## Wollongong Local Planning Panel Assessment Report | 5 September 2018

<b>IHAP No.</b>	Item 3
<b>DA No.</b>	DA-2017/1306
<b>Proposal</b>	Commercial - alterations and additions to existing club building and multi-level car park
<b>Property</b>	61 Church Street Wollongong; Lot 103 DP 1148604
<b>Applicant</b>	New England Constructions Pty Ltd
<b>Responsible Team</b>	Development Assessment and Certification - City Centre Team (TW)

### ADDENDUM REPORT AND RECOMMENDATION

Figure 1: Extract of Lower ground floor plan showing the location of waste room

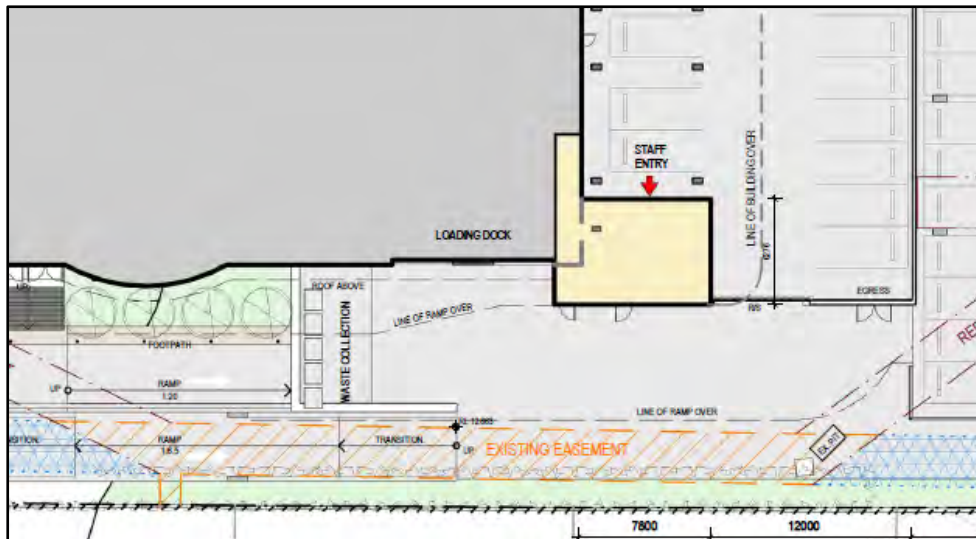
The applicant has submitted a Site Waste Minimisation and Management Plan as required by the DCP. This plan deals with demolition and construction waste as well as ongoing waste management associated with the occupation of the development. The applicant has indicated that existing waste management arrangements will continue to be utilised. The proposed site plan indicates that waste will be stored in an area in the southern part of the building. Waste collection vehicles will enter the site via the Church Street frontage and will reverse into the waste storage area, will collect waste and then leave in a forward direction out via the Kembla Street driveway.

The plans have been reviewed by Council's Traffic Section and are satisfactory.
